**AGENDA
for the
REGULAR MEETING
of the
CITY of KINGSPORT
GATEWAY REVIEW COMMISSION**

- a. Project #17-105-00005: Consider granting a Certificate of Appropriateness for new construction for a new Eastman Credit Union – Wilcox Business Center.
 - i. Grading Plan, Site Plan, Landscaping Plan, Lighting Plan, Architectural Renderings and Signage

Property Information	Eastman Credit Union – Wilcox Business Center		
Address	Wilcox Drive		
Tax Map, Group, Parcel	TM 76, Parcel 6.90		
Civil District	13th Civil District		
Overlay District	Gateway		
Land Use Designation	Industrial		
Acres	9.804		
Existing Use	Vacant	Existing Zoning	BC
Proposed Use	Commercial	Proposed Zoning	No Change
Owner /Applicant Information			
Name: Debra Bridwell Address: 2021 Meadowview Ln City: Kingsport State: TN Zip Code: 37660 Email: dbridwell@ecu.org Phone Number: (423) 578-7586		Request a Certificate of Appropriateness for: Building Permit for: New Construction for <u>Financial Institution</u> Real Estate Improvement for _____ Expansion or Renovation for _____	
Planning Department Recommendation			
(Approve, Deny, or Defer) The Gateway Review Commission is asked to grant approval for the sign, grading plan, site

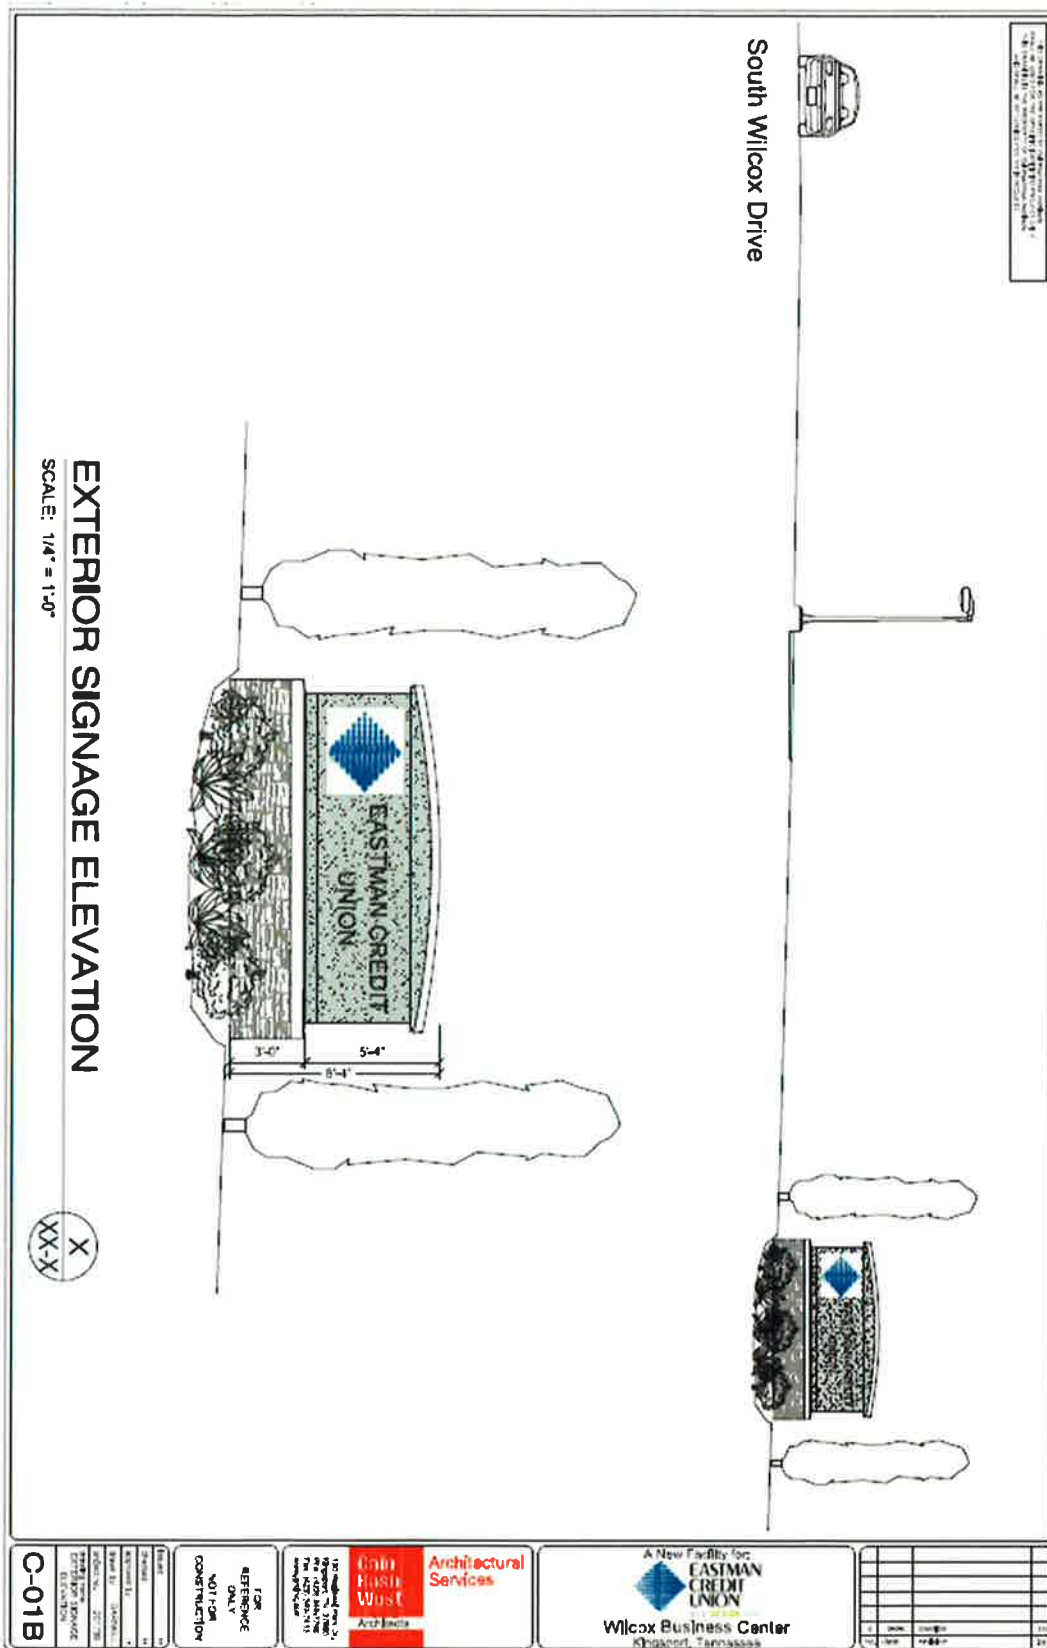
The site is allowed 75 square feet of freestanding signage. They have proposed a 8' 4" tall sign with a stone base. The sign is proposed to be 74 square feet with a significant amount of landscaping surrounding the base of the sign.

Building elevations have been provided showing a structure utilizing a combination of brick, stone, EFIS and wood. All colors are proposed to be earth tone and are in line with the Gateway requirements.

Staff is recommending approval of the grading plan, site plan, landscape plan, lighting plan, signage and architectural elevations based upon conformance to the Gateway District Regulations.
